GM SERVICE AND PARTS OPERATIONS  
DCS2032  
URGENT - DISTRIBUTE IMMEDIATELY

Subject: 07281 - Noncompliance Recall  
Head Impact Protection – Add Additional Energy-Absorbing Device

Models: 2007 Chevrolet Equinox  
2007 Pontiac Torrent  
Without Head-Curtain Side Impact Air Bags or Without Sunroof  
U.S. Vehicles and Certain Export Vehicles

**SUBJECT:** Head Impact Protection – Add Additional Energy-Absorbing Device

2055309

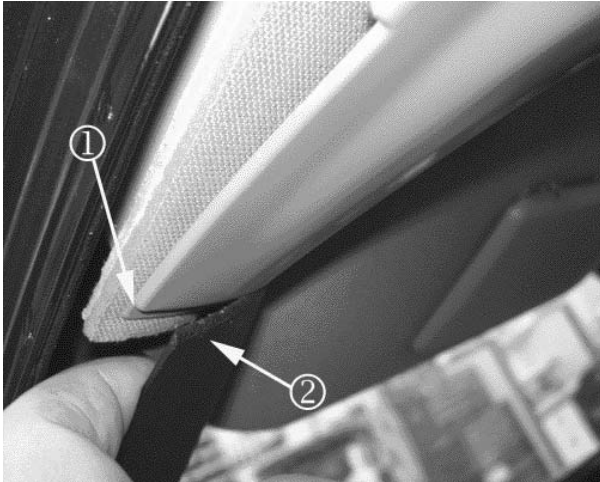
**Notice:** To avoid damaging the headliner and to ensure the headliner tab hole is cut in the correct location, it is essential to carefully align the template cross hair (1) with the edge of the headliner and the edge of the A-pillar trim. Use an X-Acto knife or equivalent utility knife to cut the tab hole in the headliner.

2. Align the template cross hair (1) with the edge of the A-pillar trim and edge of the headliner.

3. Mark the outline for the tab hole using an ink pen.
